**City of Poughkeepsie
Historic District and Landmarks Preservation Commission
Meeting Agenda**

**RE: Pelton Mount Carmel
36 North Clover Street
Revised Submission**

Re: Project: Pelton Mount Carmel
36 North Clover Street
Re: Revised design of proposed development for HDLPC Approval

REVISIONS:
11/2/2021 2021 HDLPC SUBMISSION
8/29/2019 ISSUED TO HDLPC
6/25/2019 ISSUED TO PLANNING BOARD
3/28/2019 PRE-SUBMISSION - HDLPC
11/07/2018 ISSUED TO HDLPC
8/03/2018 ISSUED TO HDLPC
3/26/2018 ISSUED TO PLANNING BOARD
1/24/2017 ISSUED TO HDLPC

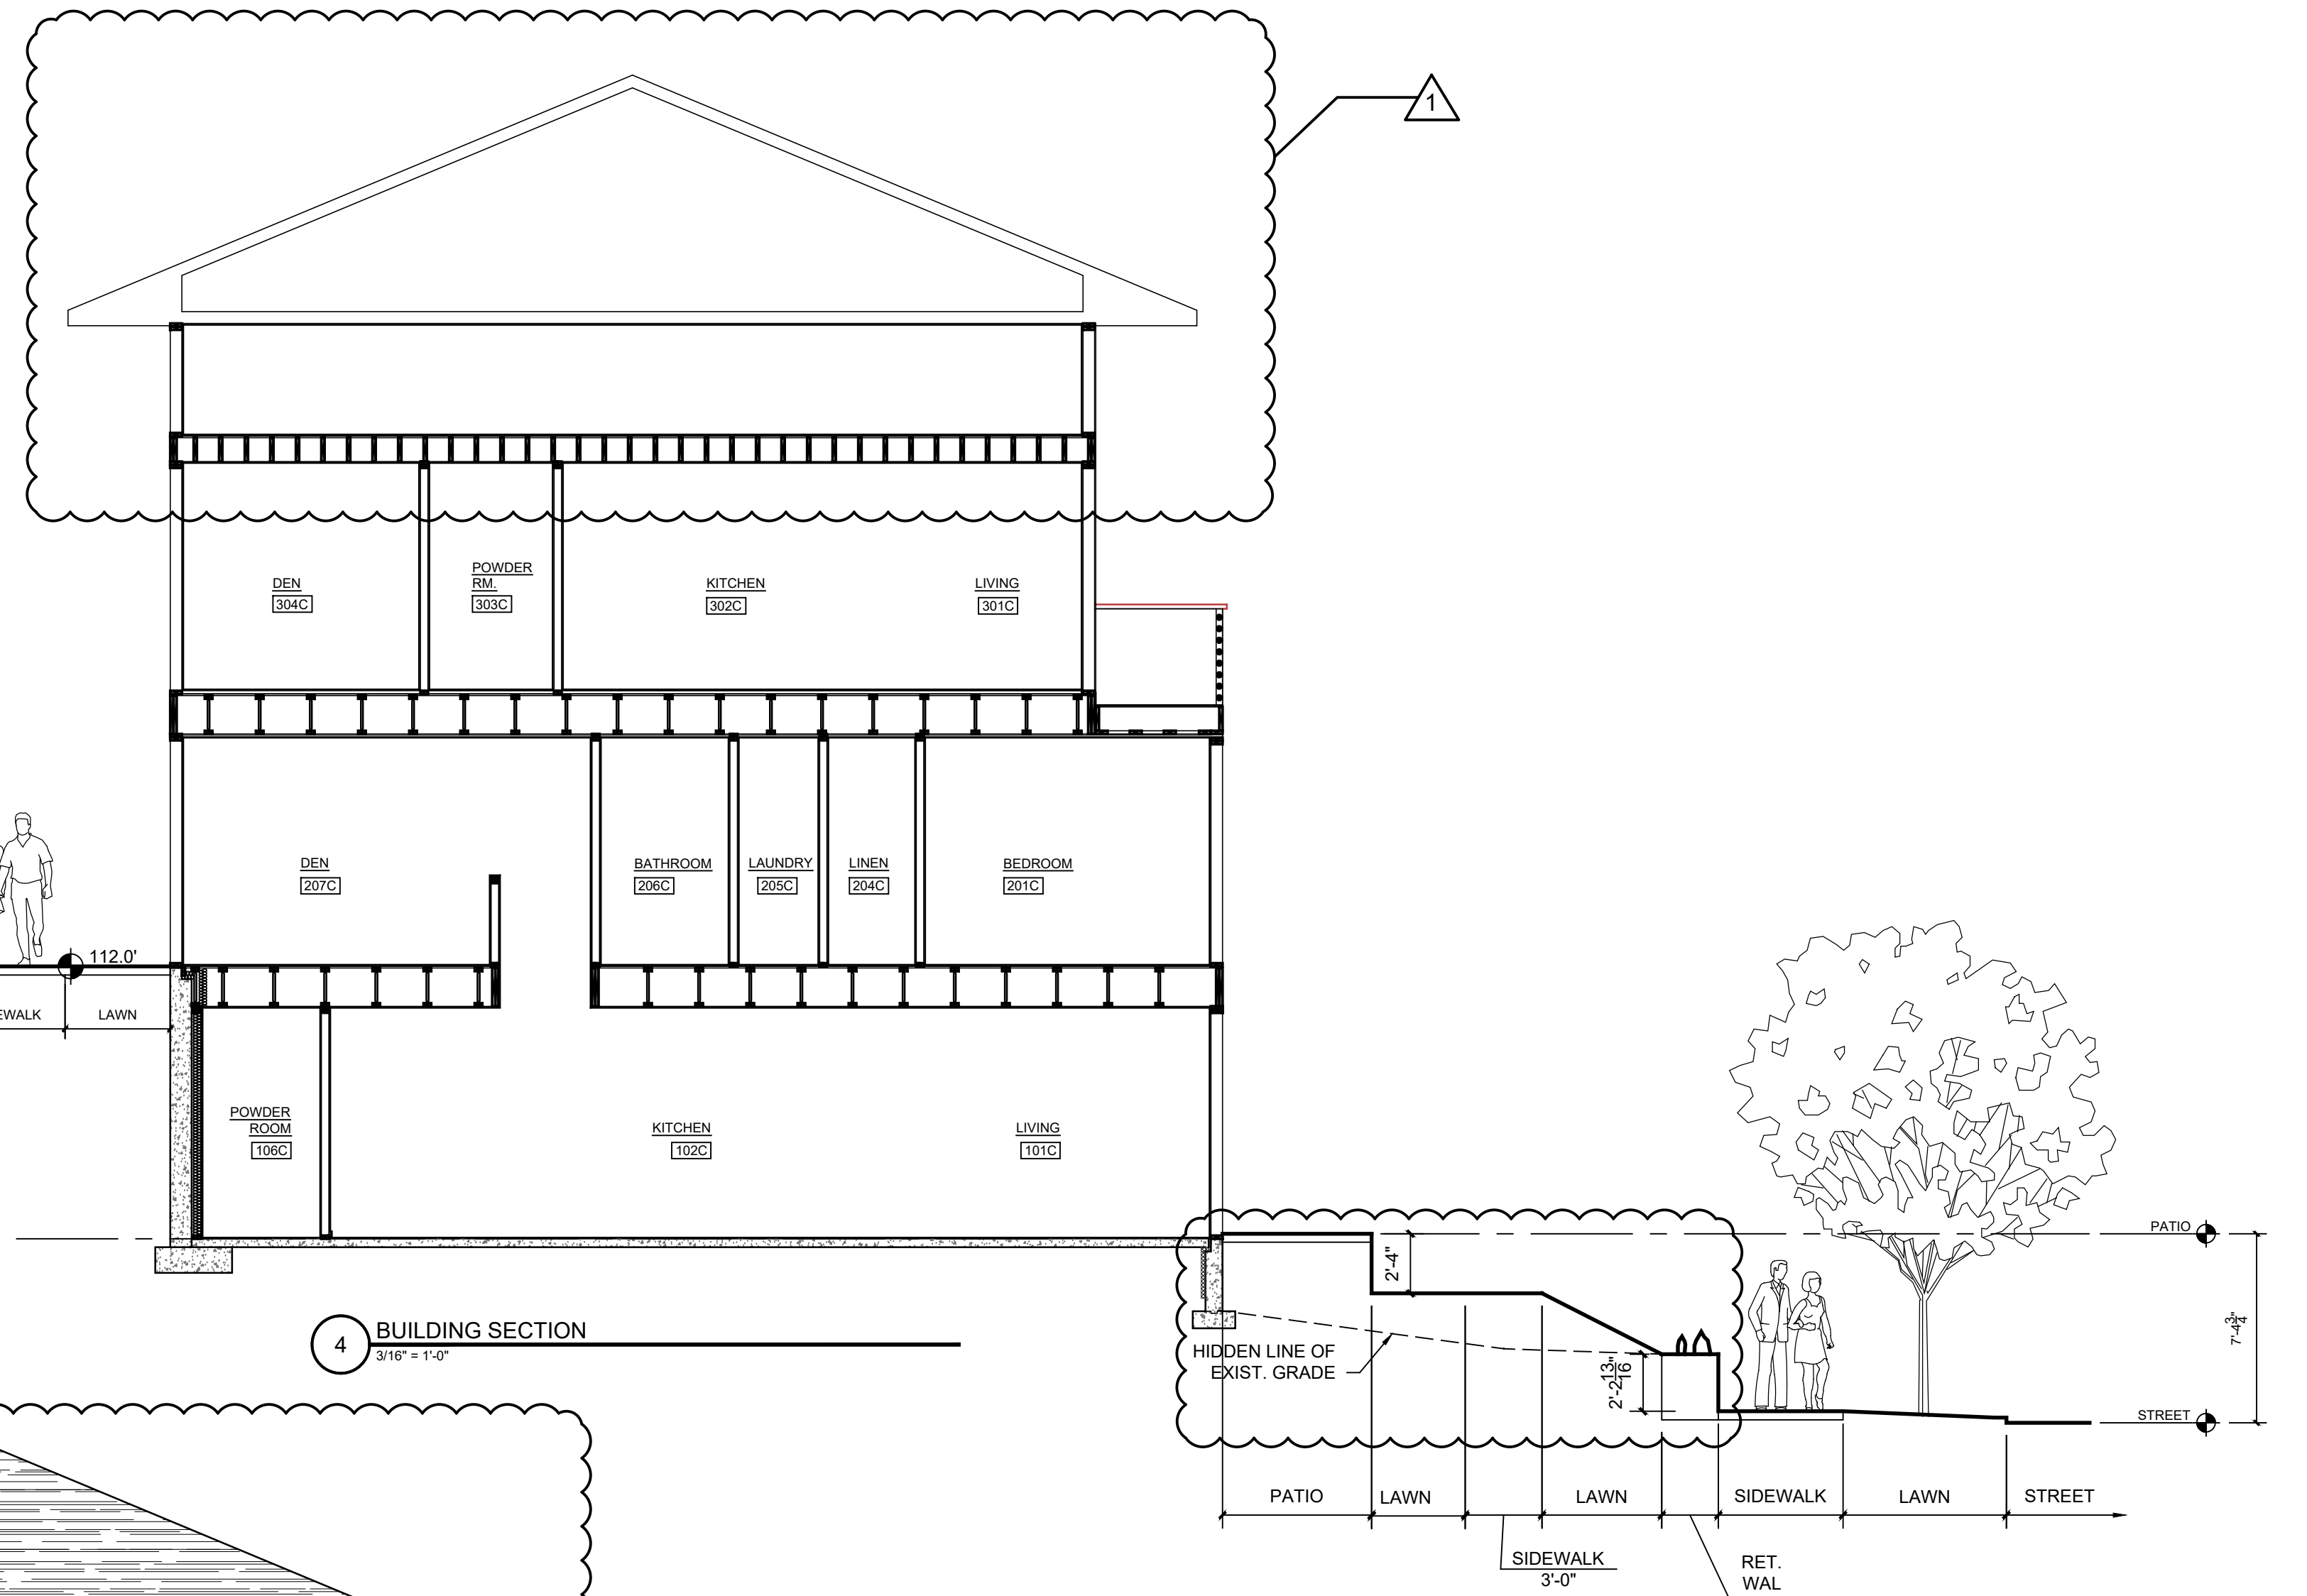
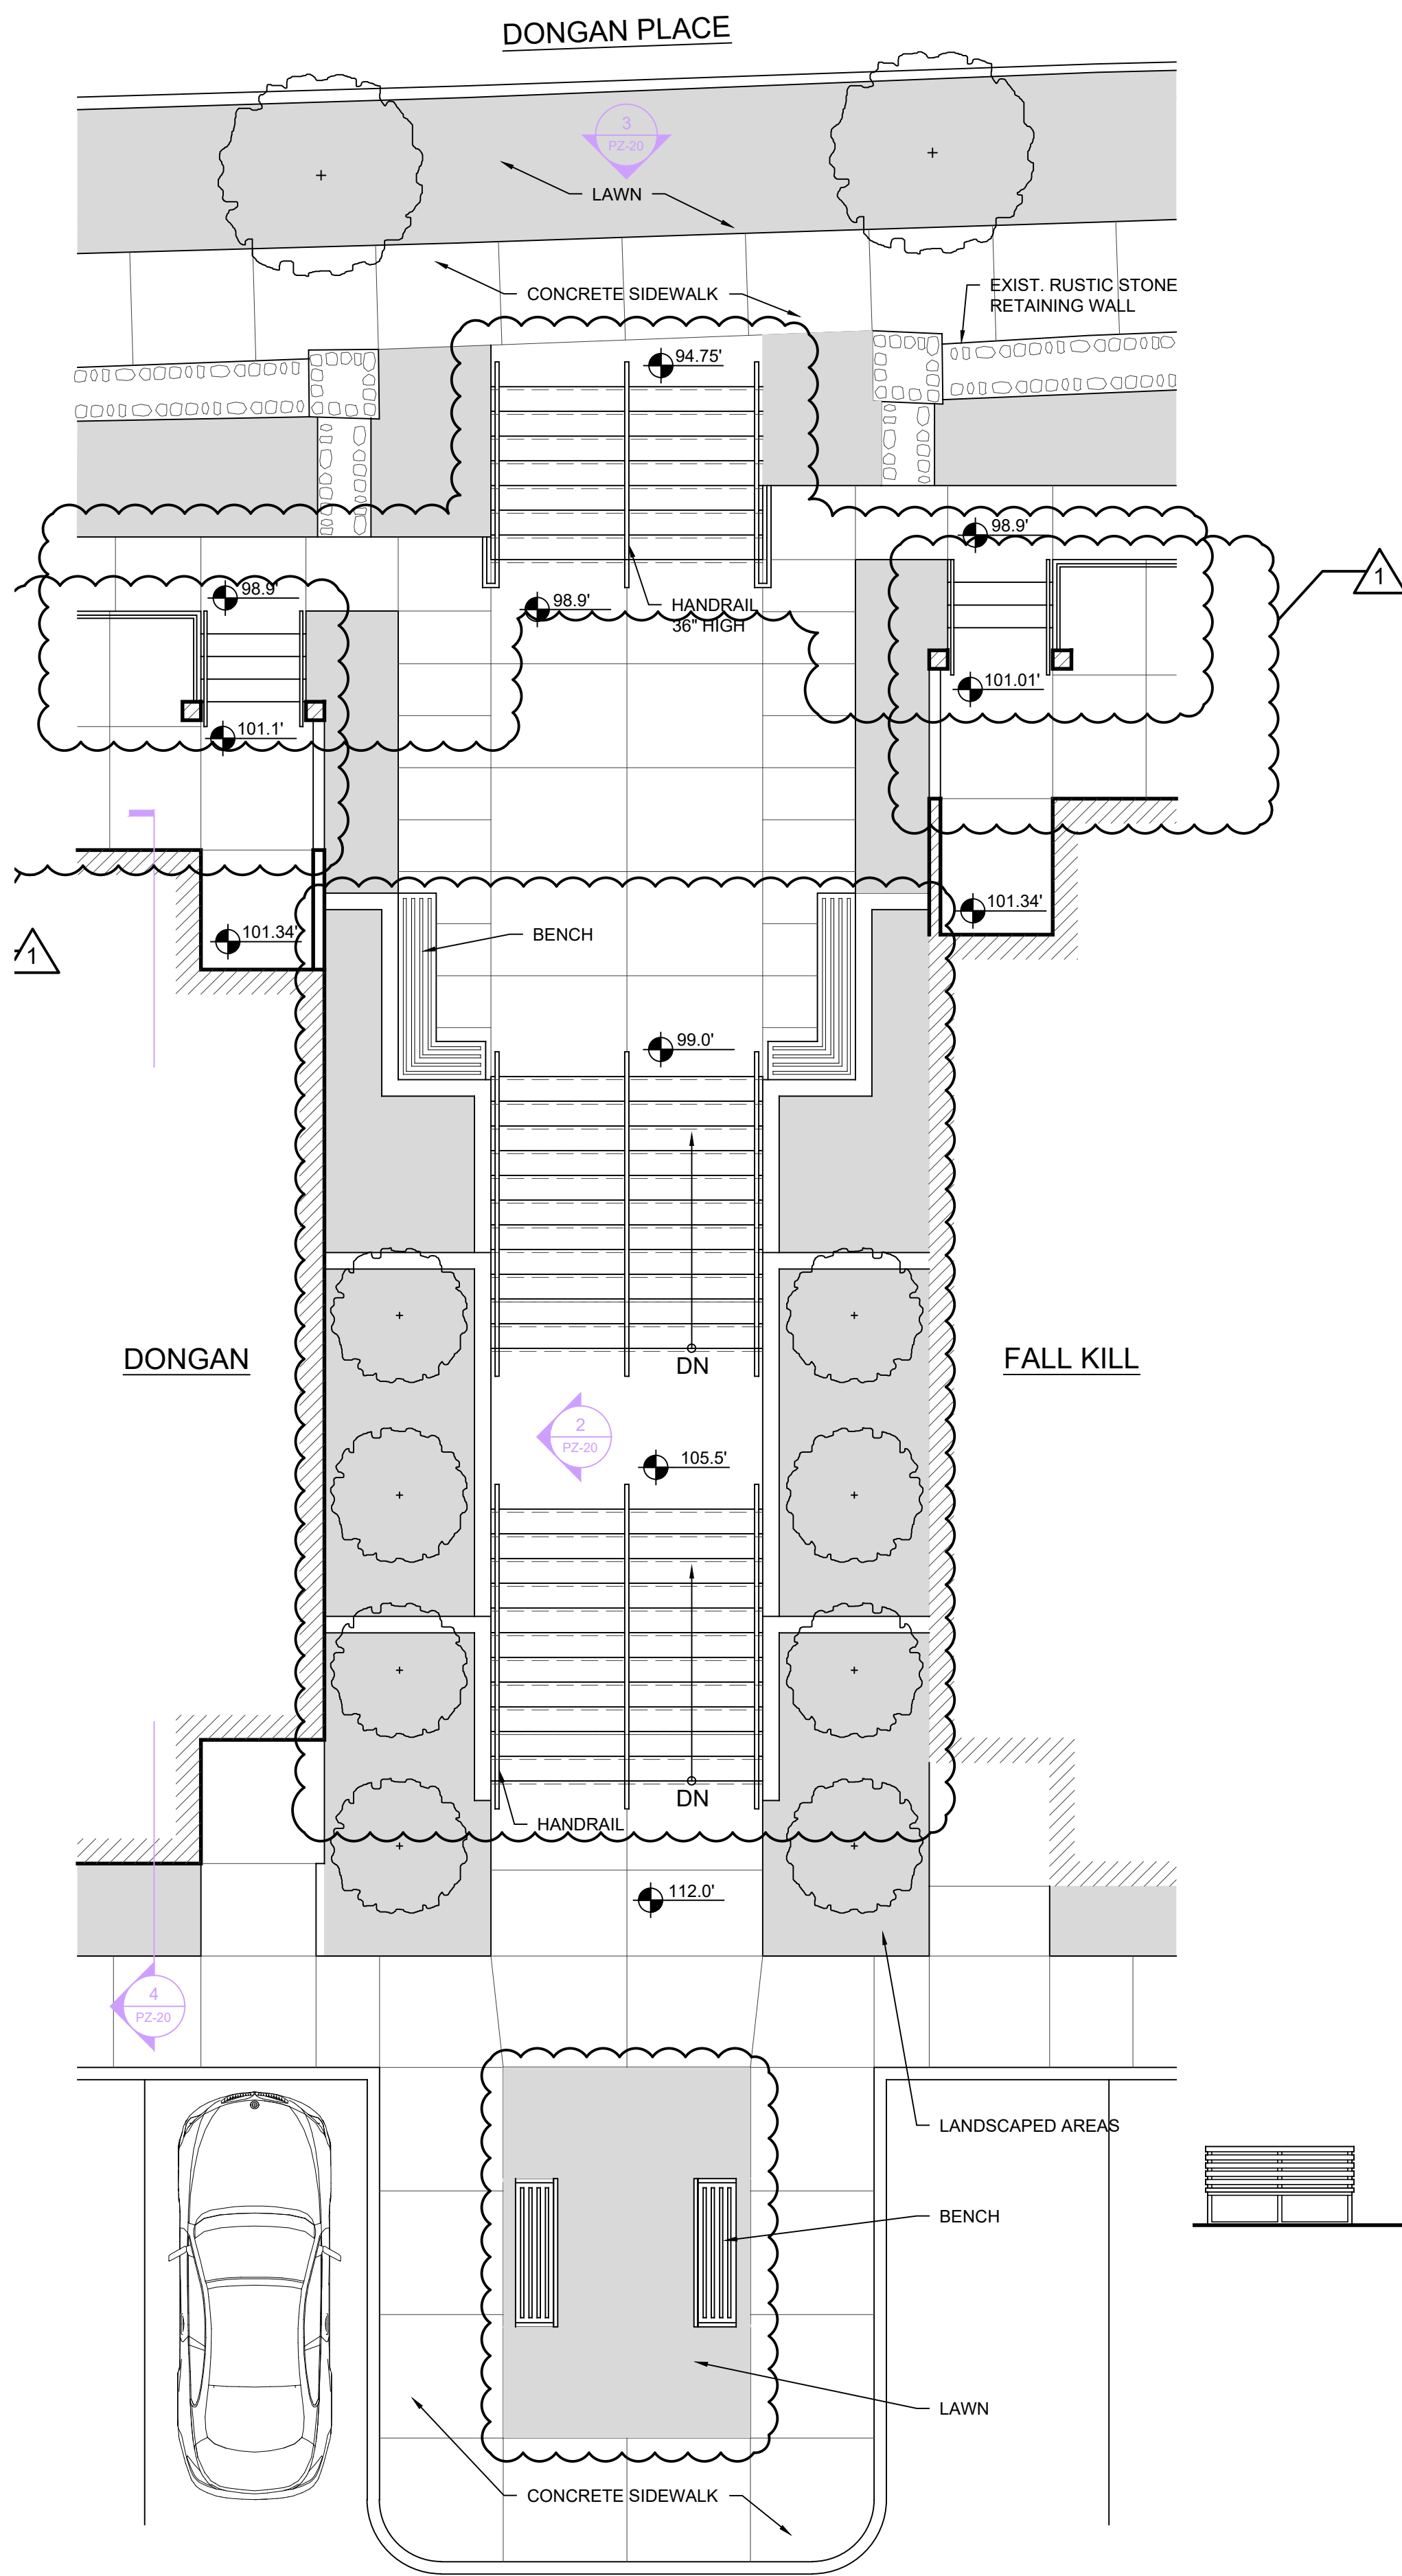
Sheet PZ-20 – Enlarged Monumental Stair Plan & Elevations:

2. Monumental Stair Section 2
 - a. The east elevation of the Dongan Building has been modified to reflect the reduction in height of the building, the new roof line as well as the elimination of the window on the Lower Duplex Level to accommodate the commercial use. Refer to Sheet PZ-12.
3. Building Section 4
 - a. The Upper Duplex Level 2 has been removed and the roof assembly has been lowered. Refer to Sheet PZ-12 for additional information.
